STATE OF WASHINGTON
DEPARTMENT OF ECOLOGY

March 07, 2024

Re: Ecology Comments on Draft Agreed Order Remedial Investigation Work Plan
TECT Aerospace Everett
2933 109th St SW, Everett, WA 98204
Facility Site No.: 17392
Cleanup Site ID No.: 12071

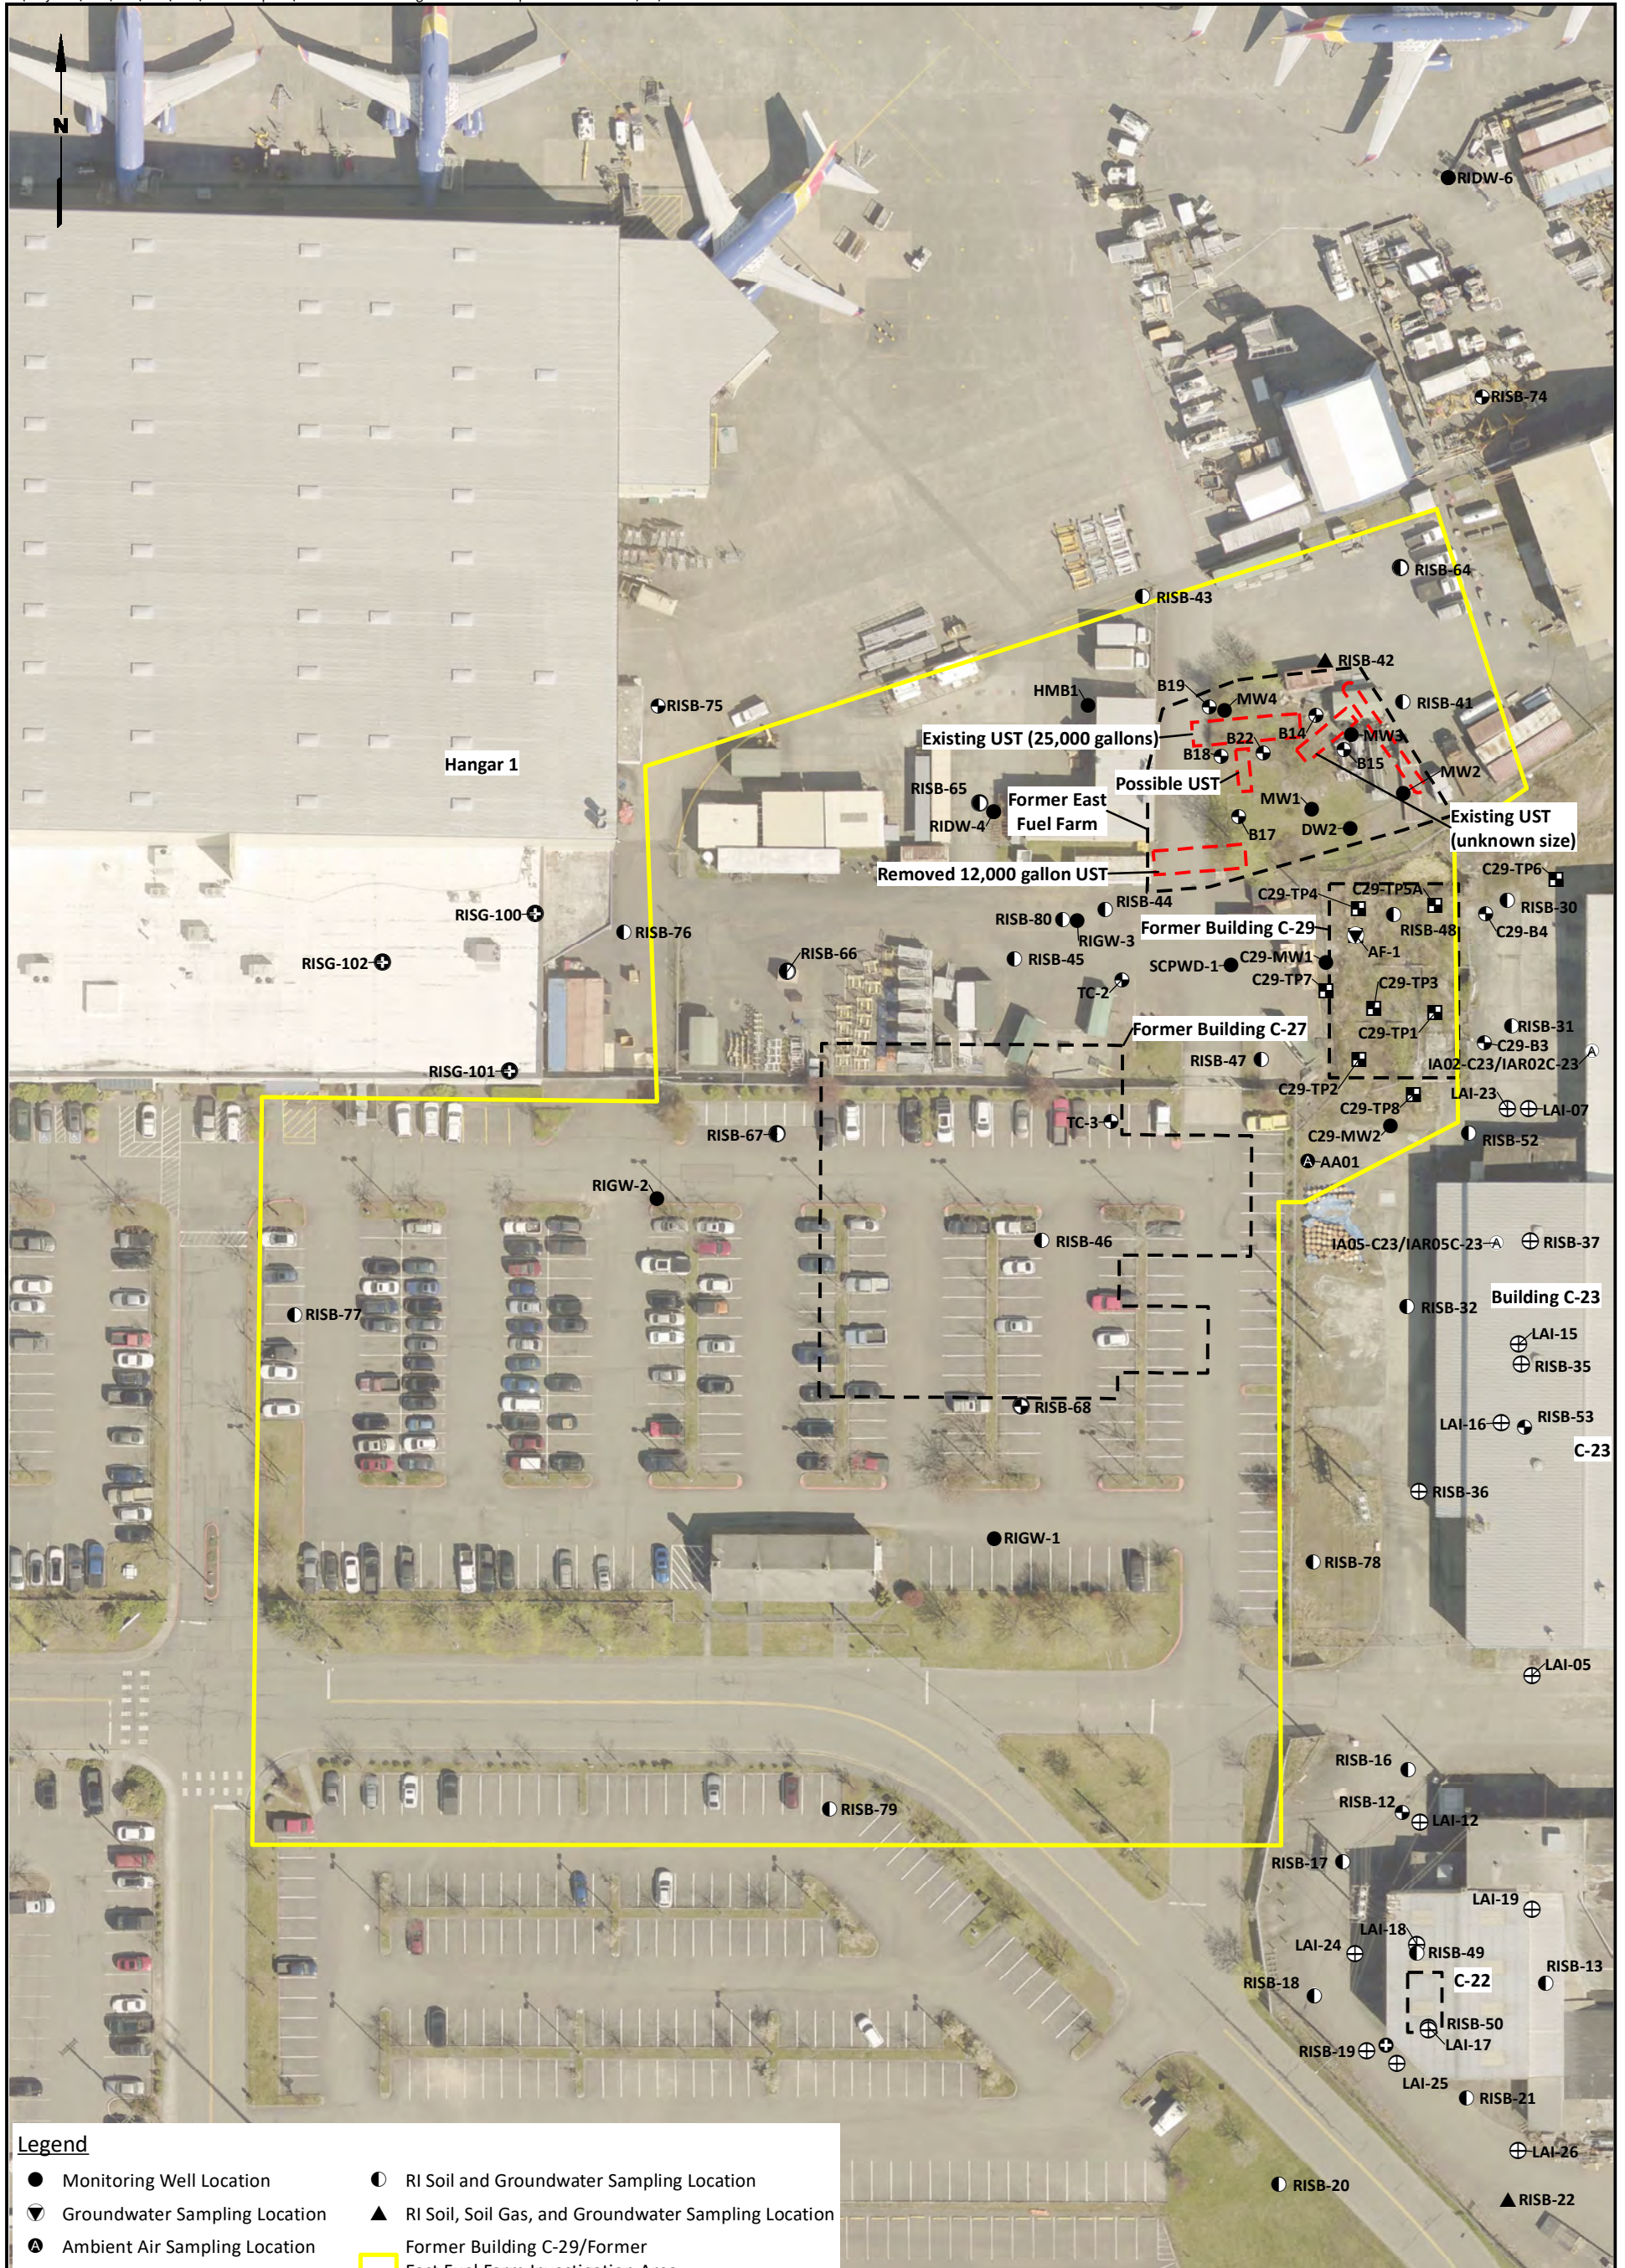
- **Building C-27, C-29, and Former Fuel Farm Area**
 - To evaluate soil gas characteristics in this area, explorations RISG-209 to RISG-218 are proposed in two transects. In the figures provided in the *December 2023 Draft AO RIWP*, RISG-215 to RISG-218 are shown extending east from RISG-209 toward Building C-23. Building C-23 is not currently occupied. Ecology requests these samples be reoriented to extend west toward Hangar 1 to provide better estimation of soil gas concentrations below the occupied building.

- Ecology appreciates your inclusion of a PFAS sample from HMB-1 to characterize former releases of aqueous film forming foam (AFFF) in this area. In the event HMB-1 contains PFAS above screening levels, additional groundwater samples will be necessary from adjacent monitoring wells installed in the shallow aquifer as well as the deep aquifer.

- Additional groundwater samples are needed west of RISB-77 and south of RISB-79 to fully delineate the extent of VOCs in this area. Soil samples should also be collected for analysis of VOCs in soil west of RISB-77.
